# Access Compliance Report

## Public Rights-of-Way

### (Curb Ramps)

Intersection ID: 42864	Main Street: ALBEMARLE_RD	Cross Street: LAKE_LESLIE_LN	Location: SW
ADA ID: 5EAD7C4B0BD3	Ramp Type: Perp	Initial Pass/Fail: Fail	Overall Compliance: No
Severity Score: 21.25			
Codes/Mitigation Info/Possible Solution		Field Measurements/Component Compliance

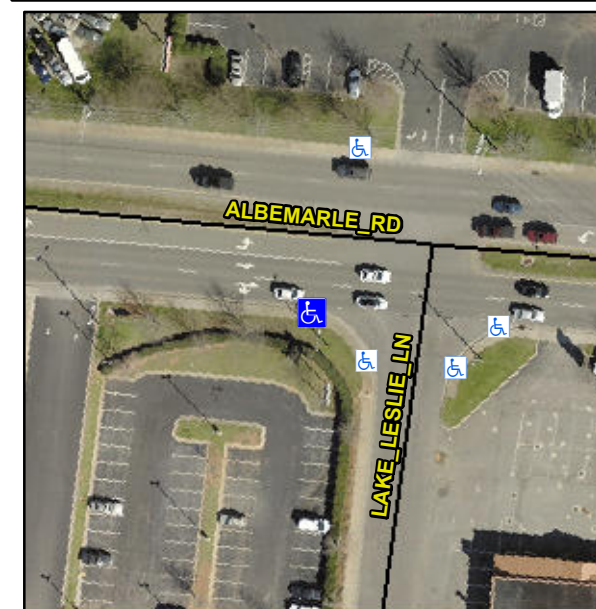
**R304.5.1, R304.2.2**

Compliance	Description	Data	Compliance	Description	Data
N/A	Ramp Length (in)	60.0	No	Ramp Slope (%)	8.9
No	Ramp Width (in)	47.0	Yes	Ramp XSlope (%)	0.7
N/A	Flare Type LT	N/A	N/A	Flare Type RT	N/A
N/A	Flare Slope LT (%)	N/A	N/A	Flare Slope RT (%)	N/A
N/A	Flare Traversable LT?	N/A	N/A	Flare Traversable RT?	N/A
N/A	Landing Length (in)	N/A	N/A	DWS Provided?	N/A
N/A	Landing Width (in)	N/A	N/A	DWS Contrast?	N/A
N/A	Landing Slope (%)	N/A	N/A	DWS Length (in)	N/A
N/A	Landing X Slope (%)	N/A	N/A	DWS Full Width?	N/A
N/A	Landing Curb? (Y/N)	N/A	N/A	DWS Offset (in)	N/A
N/A	Shared Landing?	N/A			
N/A	Gutter Ponding?	N/A	N/A	Gutter Slope (%)	N/A
N/A	Gutter Lip Ht (in)	N/A	N/A	Gutter X Slope (%)	N/A
N/A	Painted X Walk1?	No	N/A	Painted X Walk2?	N/A
	X Walk 1 Direction	To N		X Walk 2 Direction	N/A
N/A	X Walk 1 Width (in)	N/A	N/A	X Walk 2 Width (in)	N/A
	X Walk 1 Slope (%)	2.8		X Walk 2 Slope (%)	N/A
	X Walk 1 X Slope (%)	1.0		X Walk 2 X Slope (%)	N/A

**Remove & Replace Entire Ramp.**
